**From:** <mkleisure@firstenergycorp.com>  
**To:** <dvp1@nrc.gov>  
**Date:** 7/18/02 12:50PM  
**Subject:** Sample Plan Phase 3 - Revision dated July 15

## Davis-Besse Reactor Head Sample Characterization

### Phase 3

Figure 1. Section Plan for the Nozzle 3 Corrosion Area Cutout

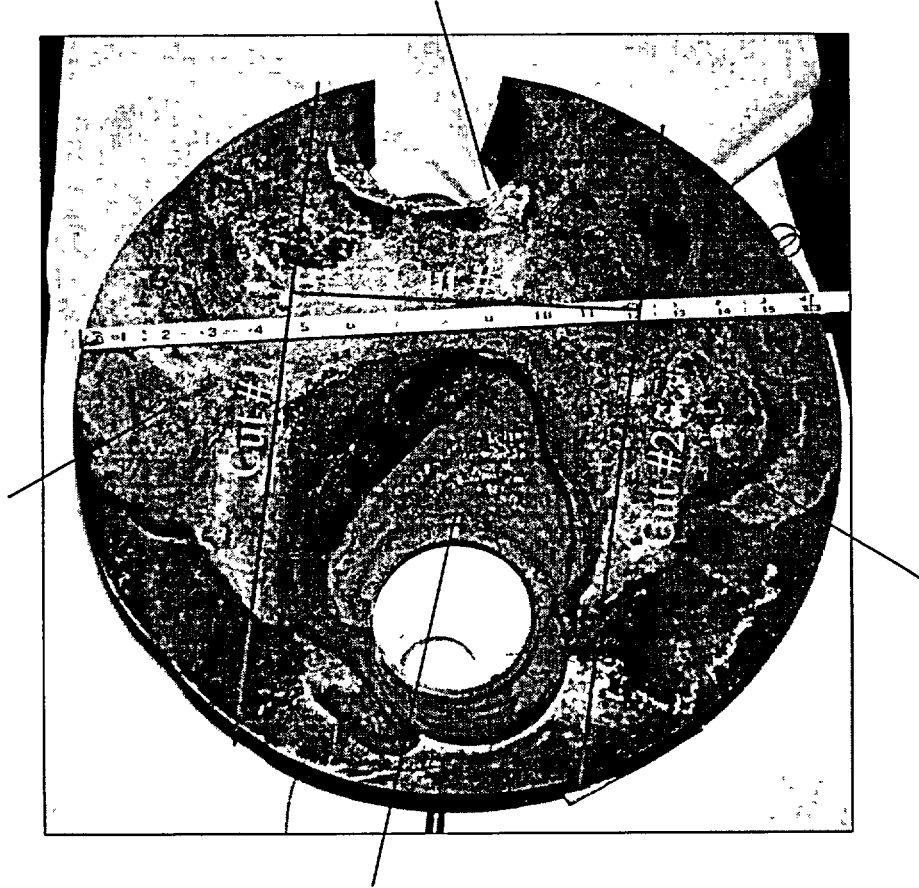
- (a) The first mold of the cavity was successfully performed with FENOC and NRC personnel concurrence on June 14, 2002.
- (b) The second mold of cavity (intended as a backup) was successfully performed with FENOC and NRC concurrence on June 27, 2002.
- (c) A mold of the stainless cladding from the underside (RCS side) of the cavity was successfully performed with FENOC and NRC personnel concurrence on June 27, 2002.
- (d) Make cuts #1, #2, and #3 as shown on Figure 1. All three cuts will be about 0.5"

minimum outside the cavity walls. The resulting four pieces will be designated as Block A, B, C, and D. Block A contains the cavity; Blocks B and C are the "moon" pieces from cuts #1 and #2; Block D is from cut #3 and contains the CRDM Nozzle 11 bore and the remaining J-groove weld.

- (g) Make cut #4 approximately 0.5" above the J-groove weld on Block D (containing the CRDM Nozzle 11 bore). Ship the portion of Block D containing the J-groove weld to ANL for additional testing (shipping information to be provided by NRC personnel). The ANL testing is not part of the work scope described herein.

- (i) Prepare the CRDM Nozzle 3 J-groove weld surface and perform fluorescent PT of all accessible surfaces of the J-groove weld for cracking.
- (j) Make cut #5 on Block A (containing the cavity) at approximately 2" above and parallel to the stainless cladding. Perform thickness measurements of the exposed stainless steel cladding in a 0.5" grid pattern.
